SUBJECT: ISSUANCE OF AMENDMENT NO. 173 TO FACILITY OPERATING LICENSE DPR-57 AND AMENDMENT NO. 113 TO FACILITY OPERATING LICENSE NPF-5 - EDWIN I. HATCH NUCLEAR PLANT, UNITS 1 AND 2 (TACs 77822/77823)

AMENDMENT NO.173TO FACILITY OPERATING LICENSE DPR-57 - Edwin I. Hatch Nuclear Plant, Unit 1
AMENDMENT NO.113TO FACILITY OPERATING LICENSE NPF-5 - Edwin I. Hatch Nuclear Plant, Unit 2

ATTACHMENT TO LICENSE AMENDMENT NO. 173

ATTACHMENT TO LICENSE AMENDMENT NO. 113

FIGURE 2.1-1
REACTOR VESSEL WATER LEVEL

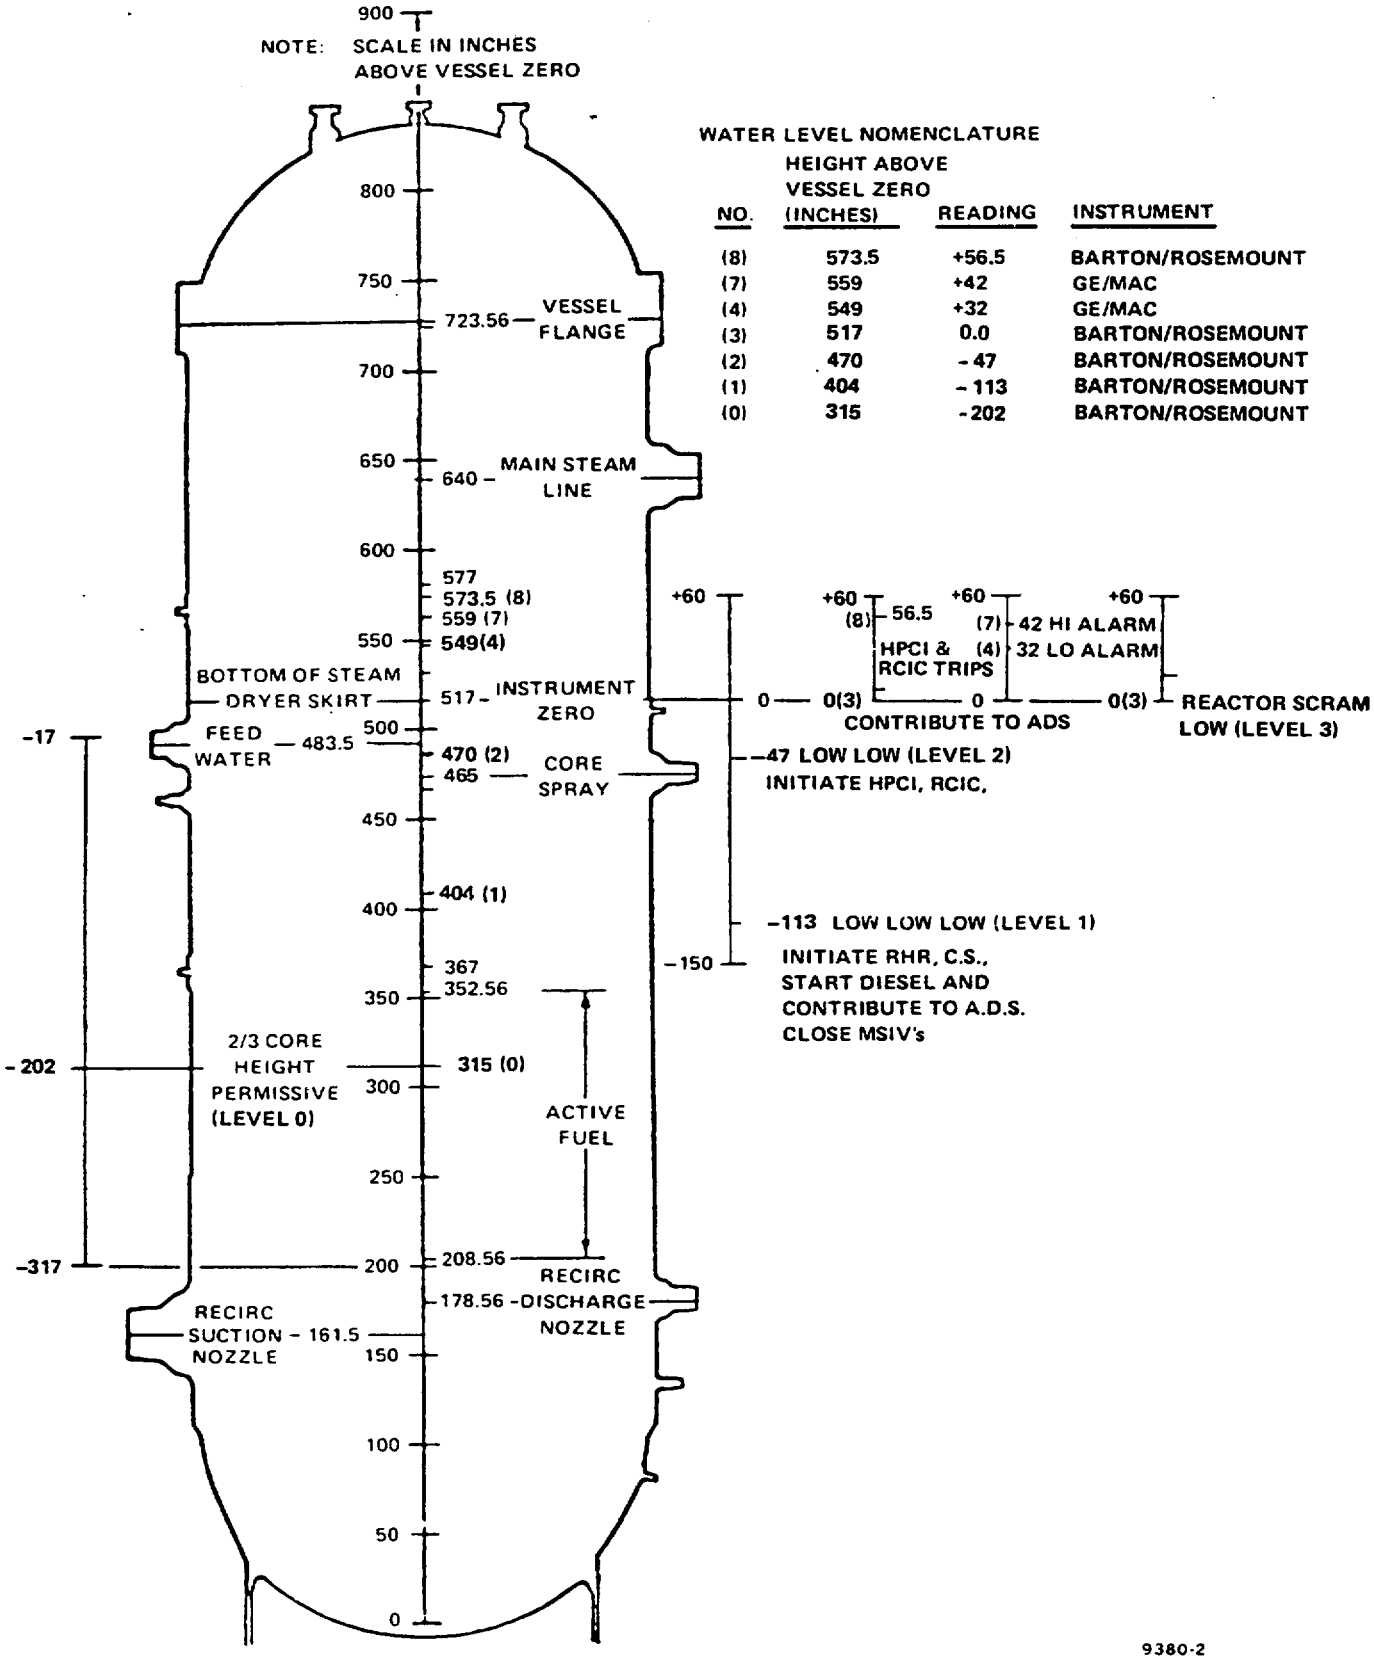
Remove Pages	Insert Pages
1.1-3	1.1-3
1.1-13	1.1-13
Figure 2.1-1	Figure 2.1-1
3.1-4	3.1-4
3.2-2	3.2-2
3.2-10	3.2-10
3.2-50	3.2-50
3.2-58	3.2-58

2. Reactor Vessel Water Low Level Scram Trip Setting (Level 3)

The trip setting for low level scram is above the bottom of the separator skirt, Figure 2.1-1. This level is approximately 14 feet above the top of the active fuel. This level has been used in transient analyses dealing with coolant inventory decrease. The results reported in FSAR Section 14.3 show that a scram at this level adequately protects the fuel and the pressure barrier. The designated scram trip setting is at least 22 inches below the bottom of the normal operating range and is thus adequate to avoid spurious scrams.

Reactor vessel water low level scram trip setting (Level 3) shall be $\geq$ 0.0 inches (narrow range scale).

BASES FIGURE B 3/4 3-1

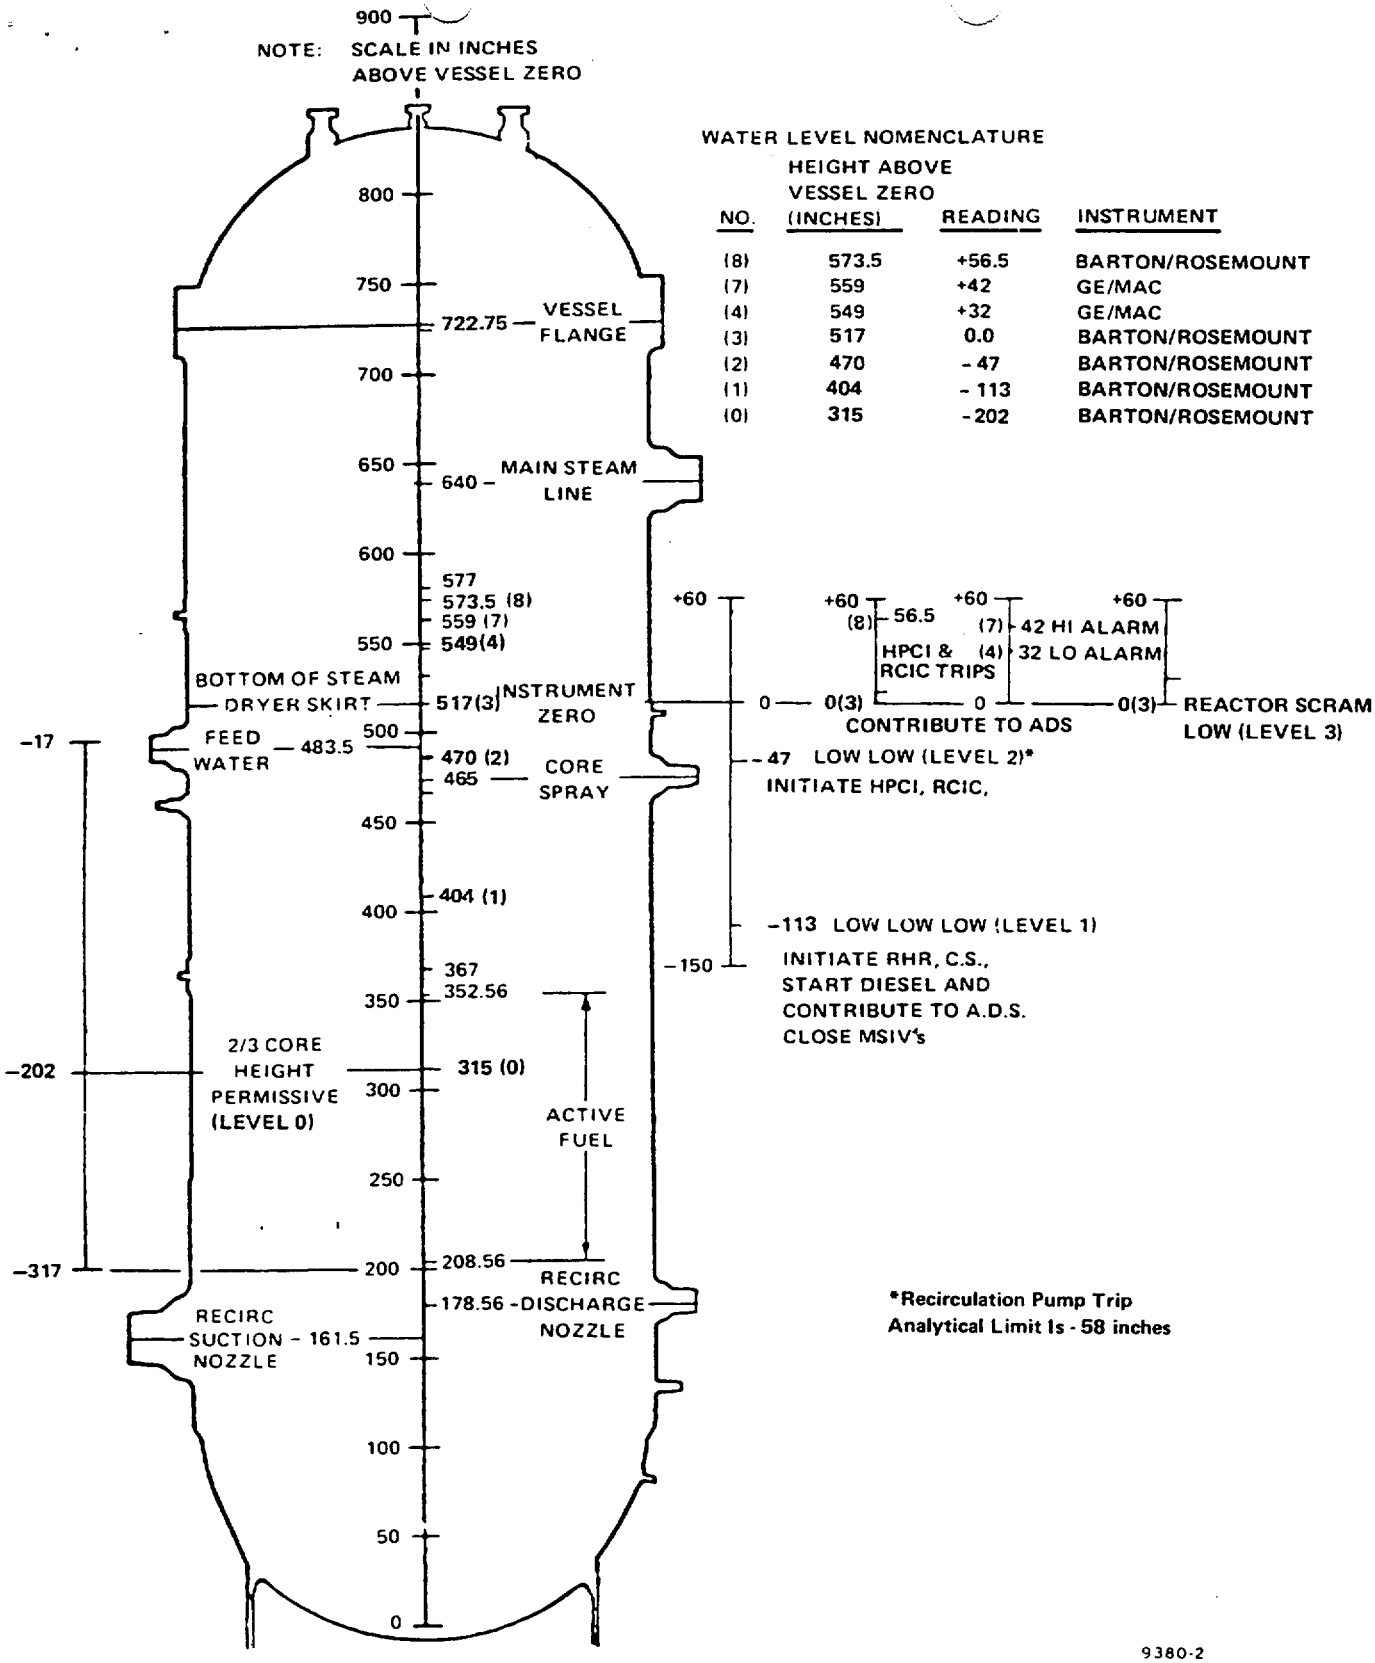
Remove Pages	Insert Pages
2-4	2-4
3/4 3-16	3/4 3-16
3/4 3-18	3/4 3-18
3/4 3-29	3/4 3-29
B 3/4 3-6	B 3/4 3-6

4. Reactor Vessel Water Level - Low (Level 3) (2B21-N680 A,B,C,D)	≥ 0 inches above instrument zero*	≥ 0 inches above instrument zero*
5. Main Steam Line Isolation Valve - Closure (NA)	≤ 10% closed	≤ 10% closed

TRIP FUNCTION	TRIP SETPOINT	ALLOWABLE VALUE
1. PRIMARY CONTAINMENT ISOLATION		
a. Reactor Vessel Water Level		
1. Low (Level 3)	≥ 0 inches*	≥ 0 inches*
2. Low Low (Level 2)	≥ -47 inches*	≥ -47 inches*
